From: Ron Wolanski, Town Planner

Date: September 4, 2024

Re: **Public Hearing** - Application of 72 Johnny Cake Hill, LLC for Development Plan Review for modification to a previously approved plan for construction of a 15,000 sq. ft. wholesale commercial use building, with associated parking, office space, landscaping, stormwater management, utilities, and associated site work, and including requests for waivers from certain design requirements of Section 521 of the Middletown Rules and Regulations Regarding the Subdivision and Development of Land. Property located on 72 Johnnycake Hill Road, Assessor's Plat 114, Lot 601.

1 NORTH ELEVATION PROPOSED  
1/8" = 1'-0"

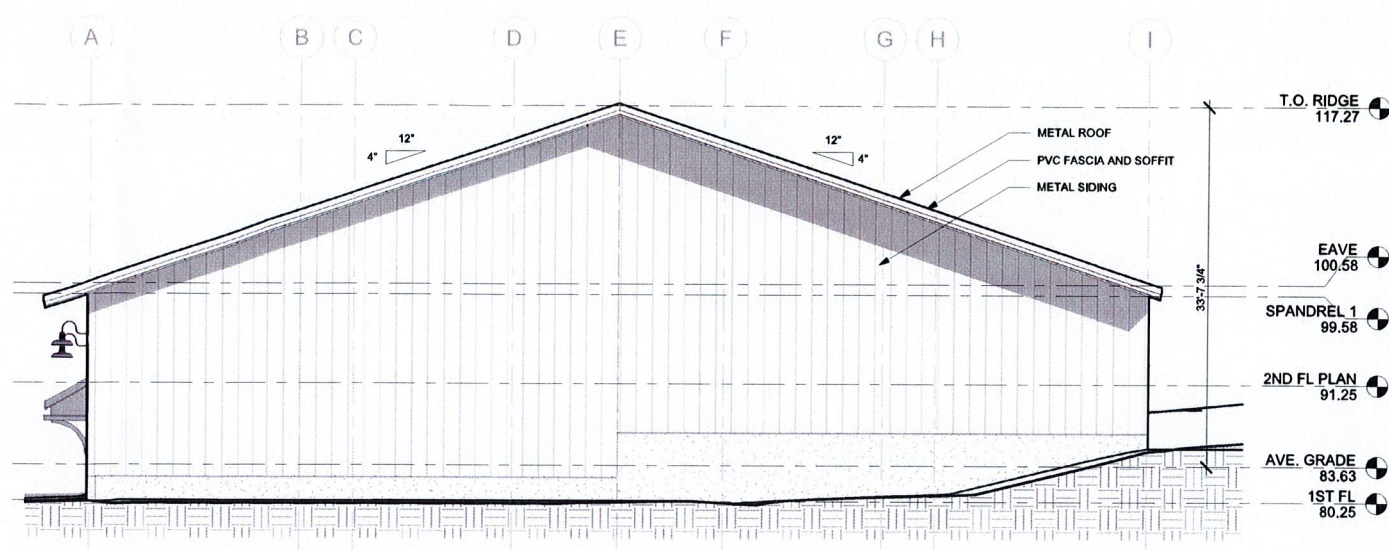
1. Section 521.2.A.2 – Street side façade does not consist of an unarticulated blank wall, does not consist of an unbroken series of garage doors, and no unbroken plane of a wall exceeds forty feet without a minimum 4 feet wide architectural design feature. Proposed street side façade consists of an unarticulated blank wall and walls exceed forty feet without a 4 feet wide design feature.

2. Section 521.2.B.1 – Windows and glass doors occupy between 20% and 60% of façade visible from the public way. No windows are proposed on the street-facing façade.
3. Section 521.2.C – Building sidings, roofs, and trim shall be constructed of traditional materials. Substitute materials may include fiber cement board, composite that resemble traditional materials, standing seam metal roofs, and non-flammable siding (Use of non-traditional or substitute materials require Planning Board or Administrative Officer approval). Building exteriors include a metal roof, metal siding, and PVC trim.
